M E M O R A N D U M

From: Timothy A. Stoepker, Dickinson Wright, PLLC

Date: September 12, 2018

Re: Trinitas Cottages at Barton Green, Ann Arbor, Michigan

Potential Building Plan Changes:

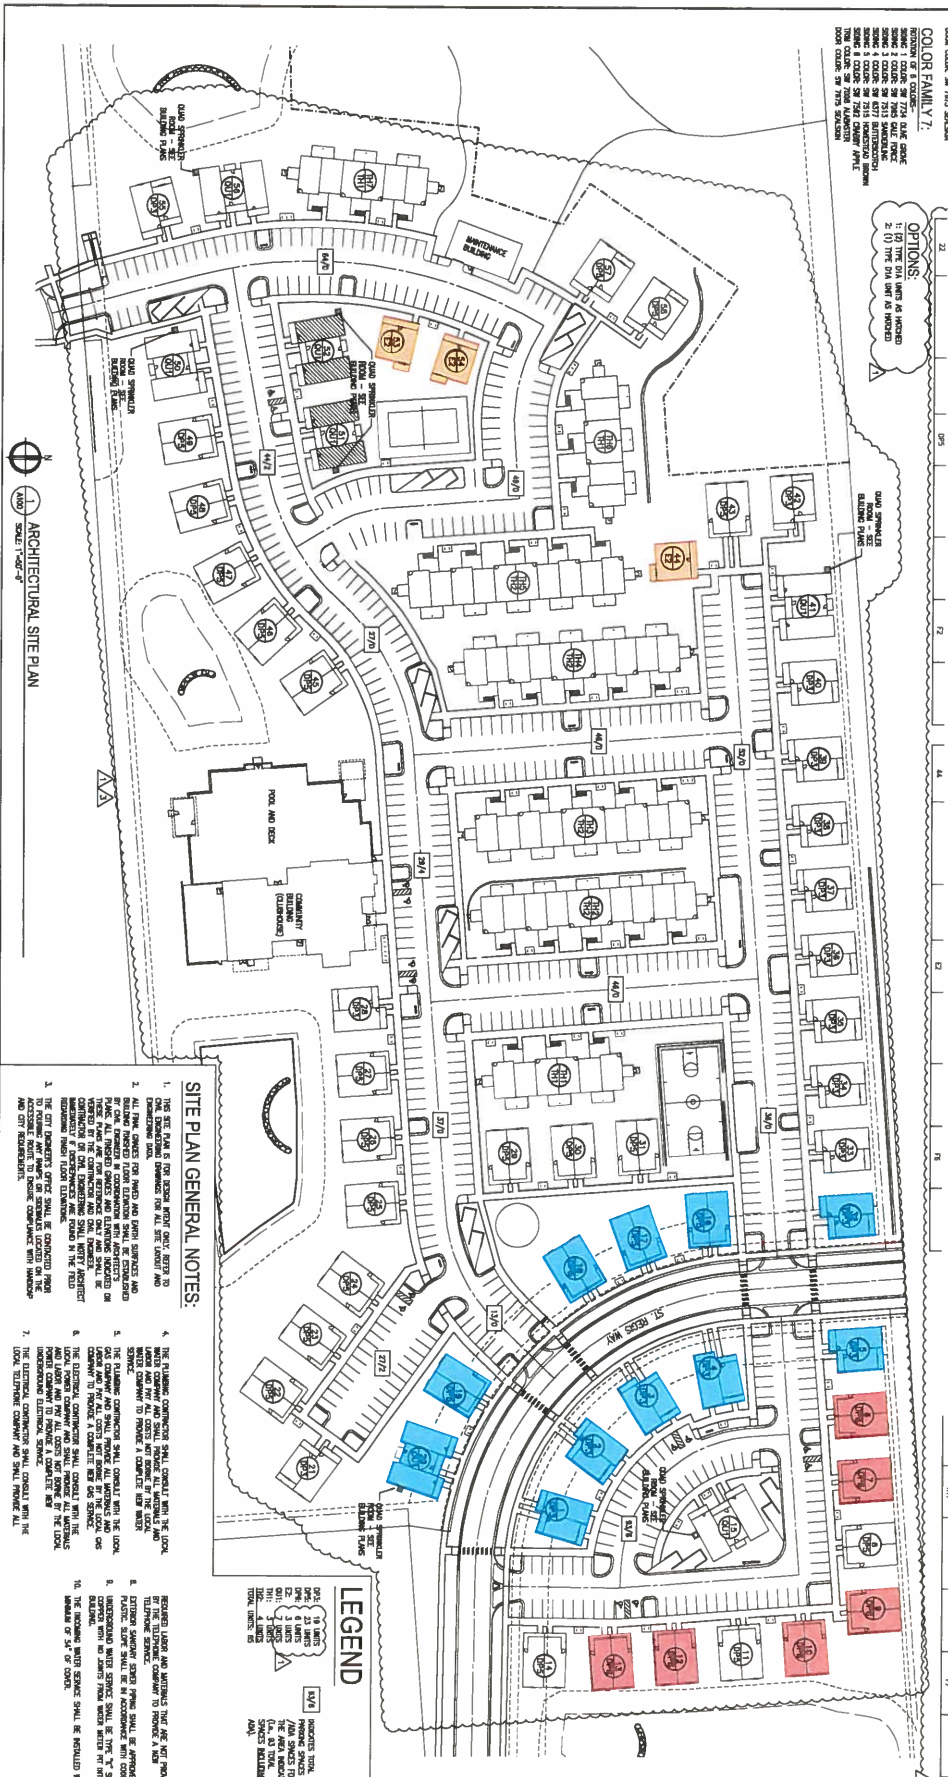
Red = DP6 units to DP5 units (Eliminate all 6 bed units)

Blue = Replace units with single-family homes and place along public street (add 8 single-family homes)

Orange = Replace E2 unit with DP5 units

Result = 8 Added single-family homes, no 6-bed units, 10 less units, and 28 less beds

Potential Vehicular and Bike Parking Plan Changes:

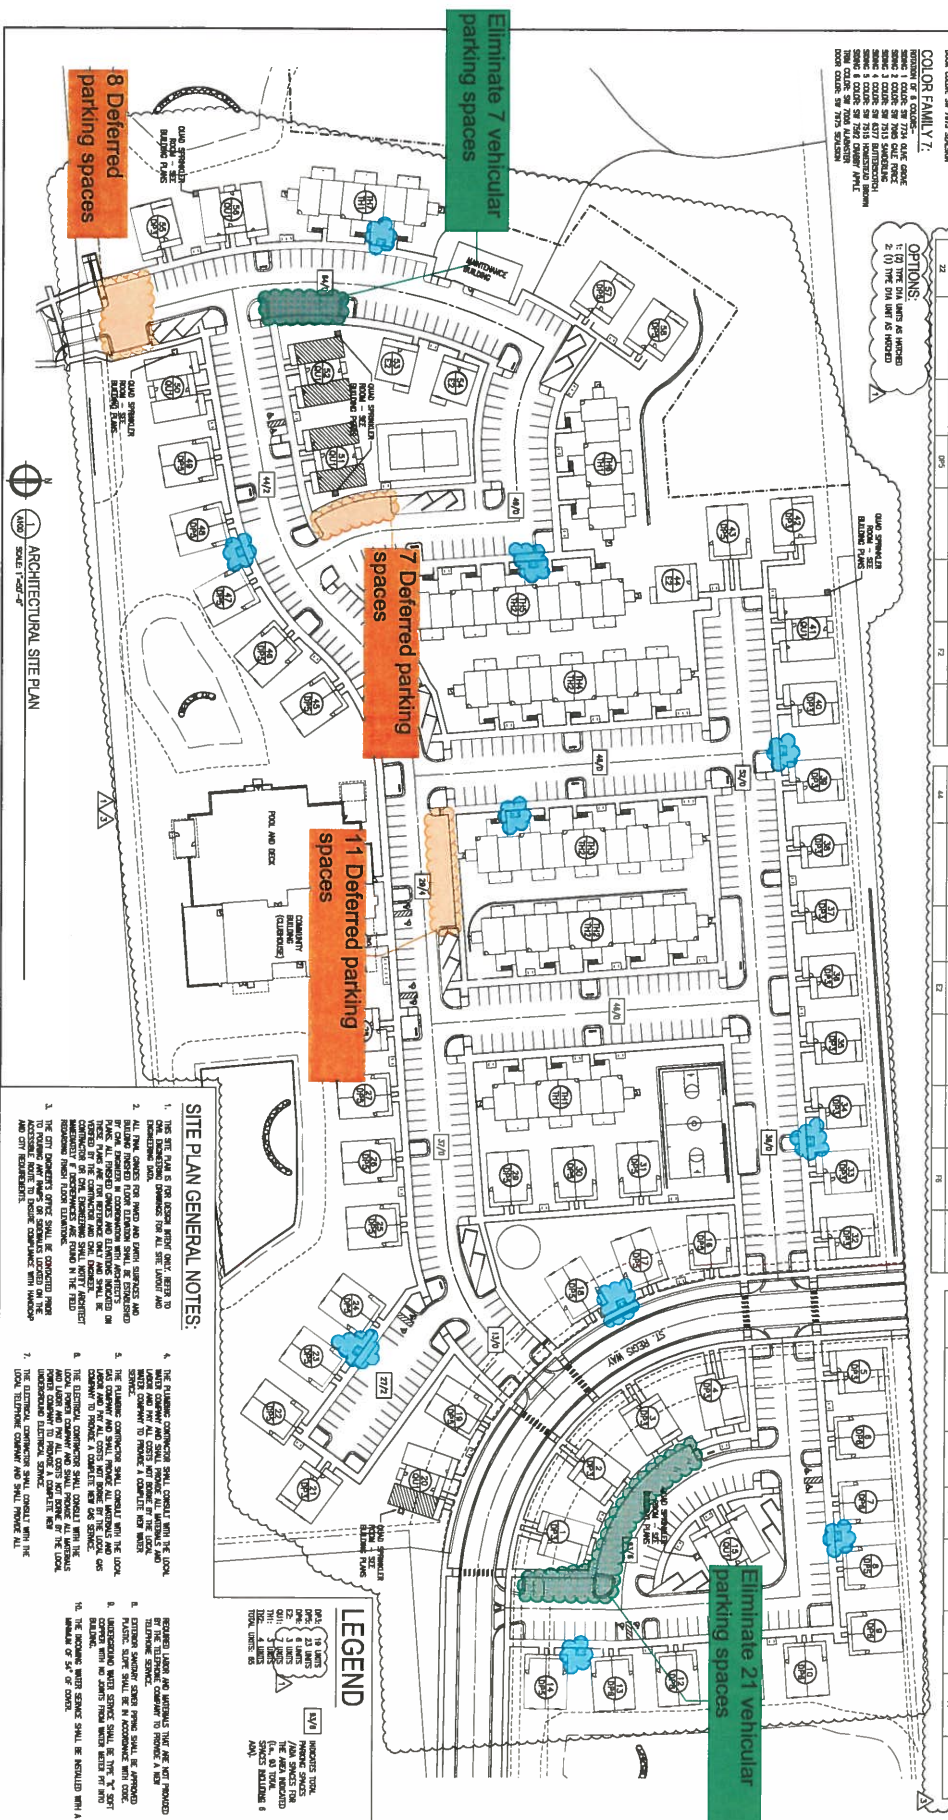
Green = Eliminate 28 vehicular parking spaces

Blue = Replace class C bike parking with class B bike parking (40 protected bike spaces)

Orange = 26 potential deferred parking spaces

Result = 54 less parking spaces and 40 added covered bike parking spots

COMMUTING TO A2 STEAM 2017-2018

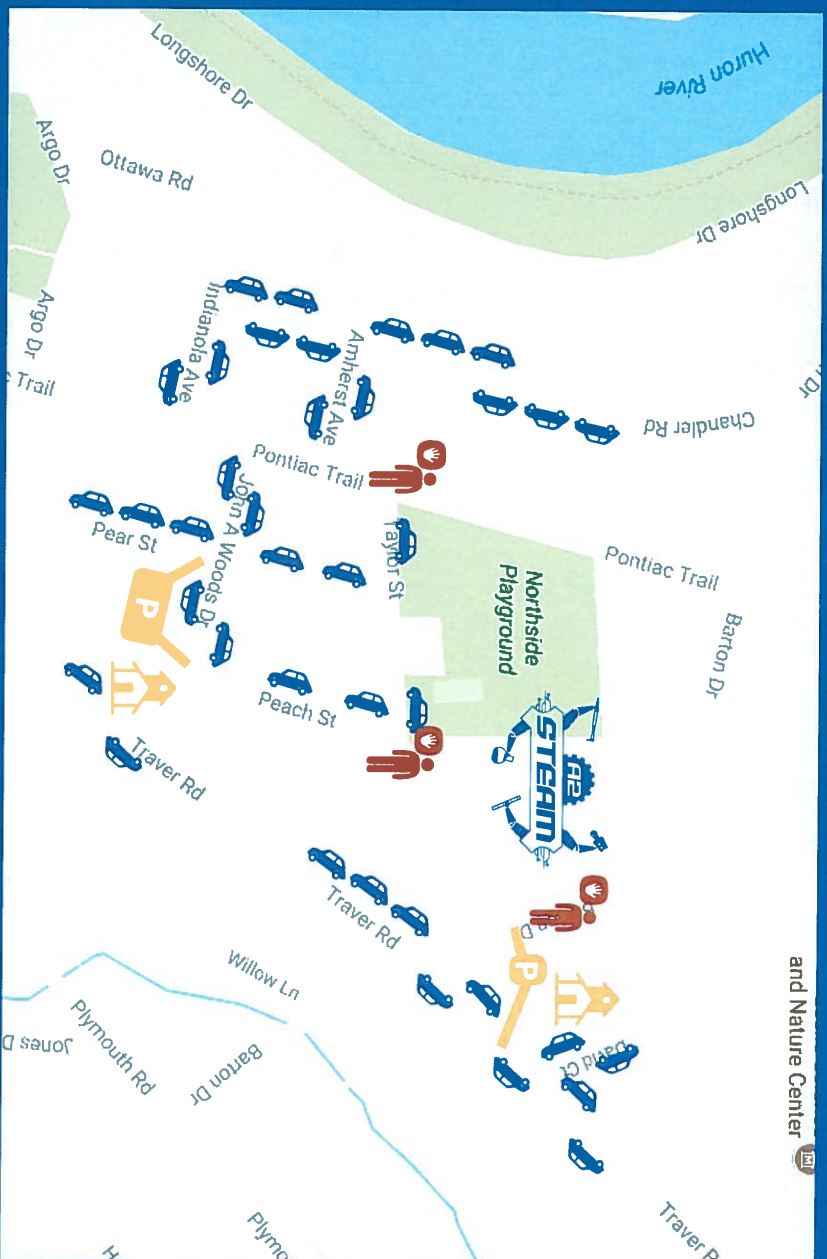
9. City verification of whether a crossing guard or other method for monitoring pedestrian crossing is warranted at Pontiac Trail near the school. Currently there are crossing guards at 3 locations adjacent to the school at the corner of Pontiac Trail and Barton Drive, Additionally, a pedestrian crosswalk and signal are located at the intersection of Pontiac Trail and Barton Drive. Please see attached diagram for locations.
